REMARKS

Appendix A - Annotated Marked-up Drawings

Amendments to the Drawings

FIG. 1

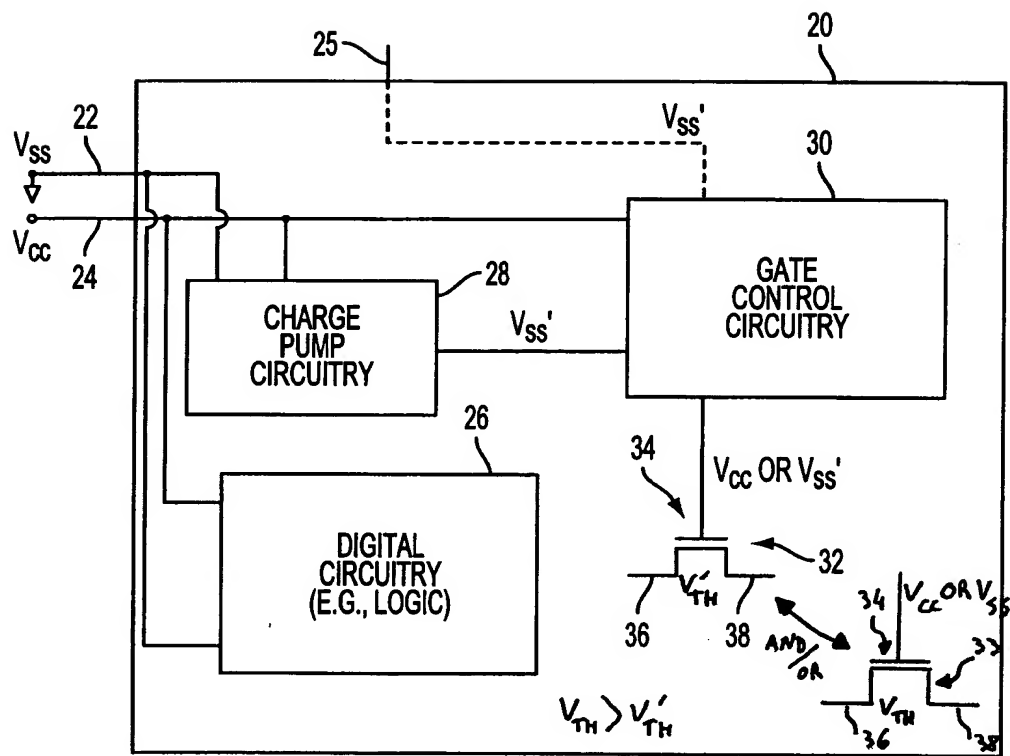
The Examiner contends that the feature "the additional transistors have higher threshold voltages than the plurality of transistors" specified in claim 15 is not shown in the drawings. Applicants have amended FIG. 1 to show transistor 33 that has a higher threshold voltage than transistor 32. Applicants have also amended the specification to reflect the amendments to FIG. 1.

Please approve the following amendments to FIG. 1 as indicated in red in the attached copies of the formal drawing for FIG. 1:

Add transistor 33.

Add text -- V_{TH}' --, -- V_{TH} --, -- $V_{TH} > V_{TH}'$ --,
and -- V_{CC} or V_{SS} --.

Add reference numerals --33--, --34--, --36--,
and --38--.

FIG. 3

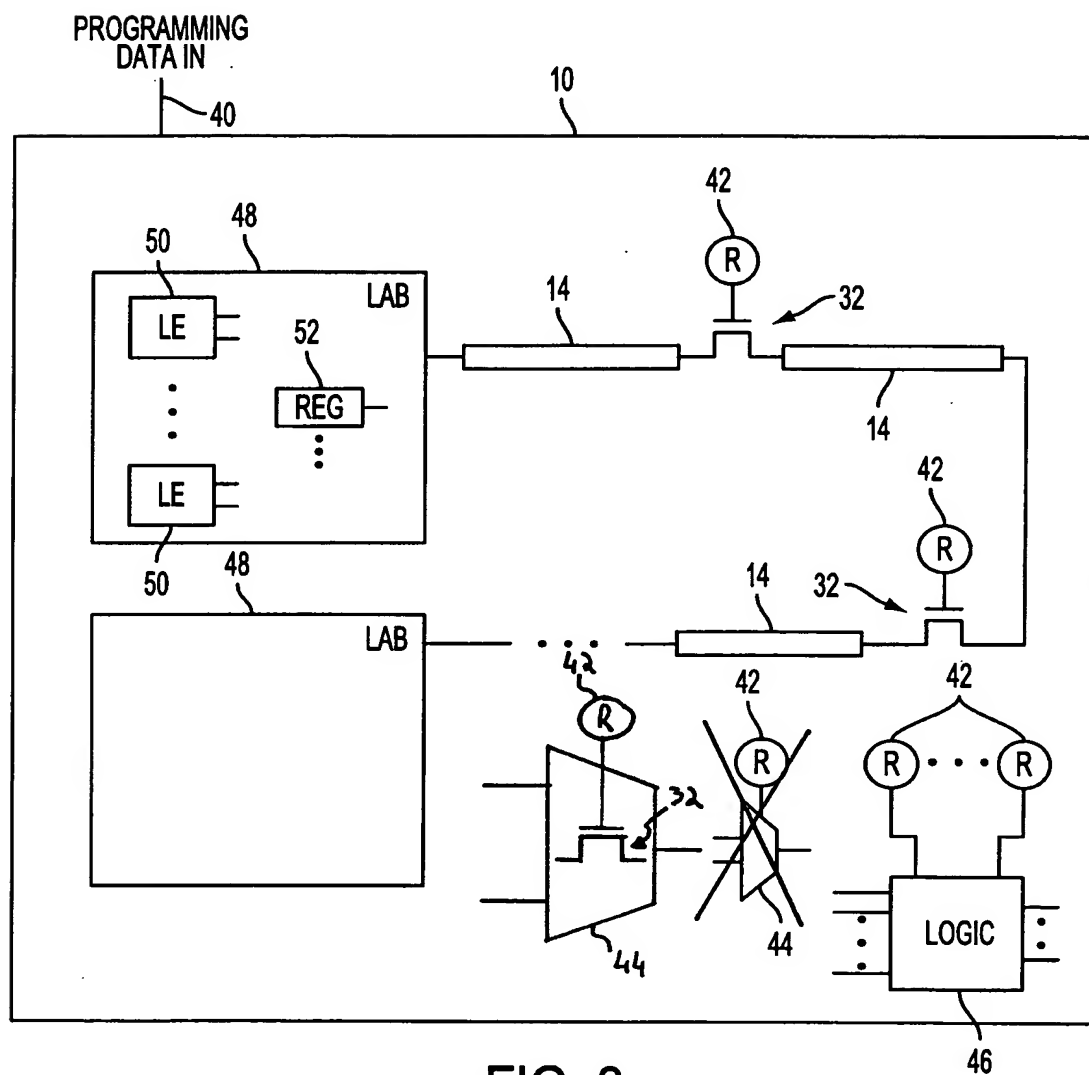
The Examiner contends that the feature "at least some of the transistors are included in the multiplexer" specified in claim 11 is not shown in the drawings. Applicants have amended FIG. 3 to show one embodiment of the invention in which at least some transistors are included in a multiplexer.

Please approve the following amendments to FIG. 3 as indicated in red in the attached copies of the formal drawing for FIG. 3:

Replace multiplexer 44 with amended version of multiplexer 44.

Add reference numeral 32.
